Wellhead System Specifications (For Five (05) Wells)
Specification Sheet of ESP Well Head System, 5000 PSI Working pressure
All Material to be as per API 6A LATEST EDITION, PSL-3, PR-2, Temperature Class 'U' Material, Class 'EE-0.5'

Proposal for Recompletion Tubing Spool with Hanger and Rotary adapter

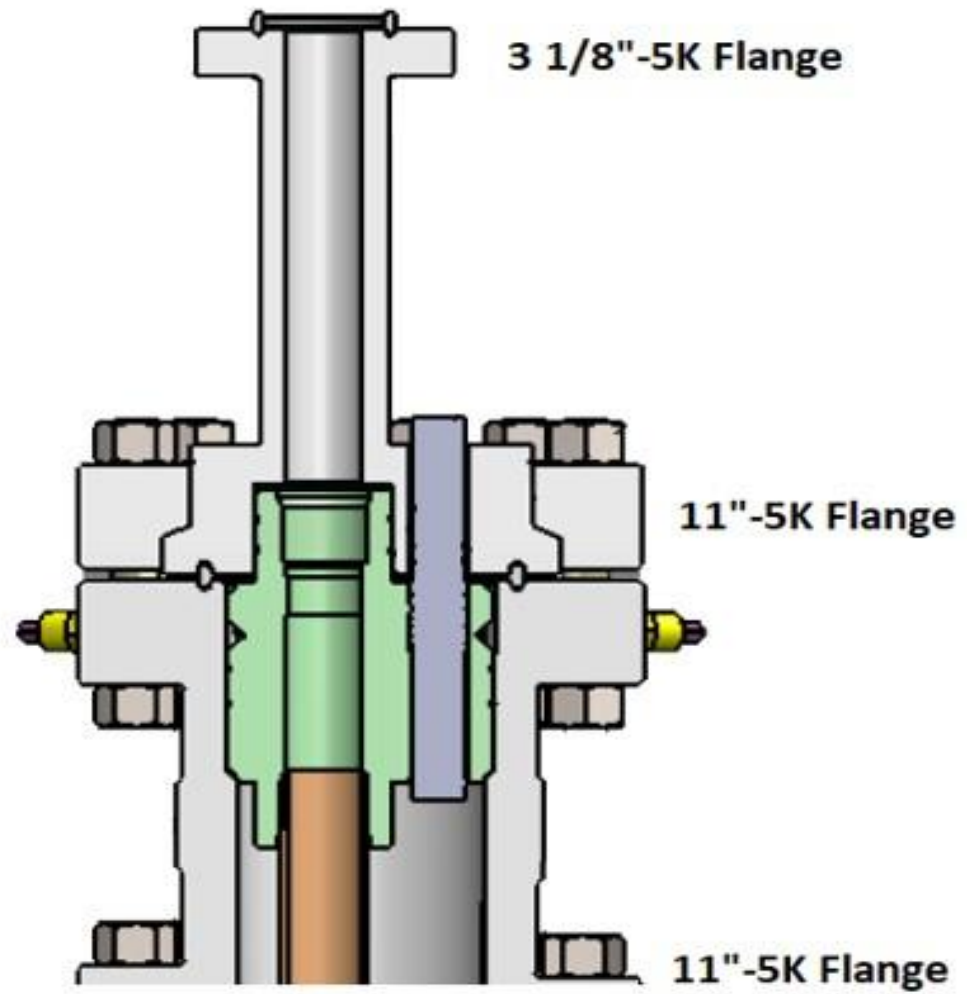
7	Companion Flange 3-1/8" 5K Psi to install the 3-1/8" 5K gate valve assembly at the top of Riser Ring Gasket and Stud nuts to connect the 3-1/8" 5K Flanges	01 No for each well (05 in Total)	As per schematic representation, instead of Companion flange and riser configuration, we propose Rotary Type Adapter 11"-5K x 3 1/8"-5K which also do not require the alignment pin. Kindly confirm.	Acceptable must have provision to install 3-1/8" 5K Gate Valve Assembly.
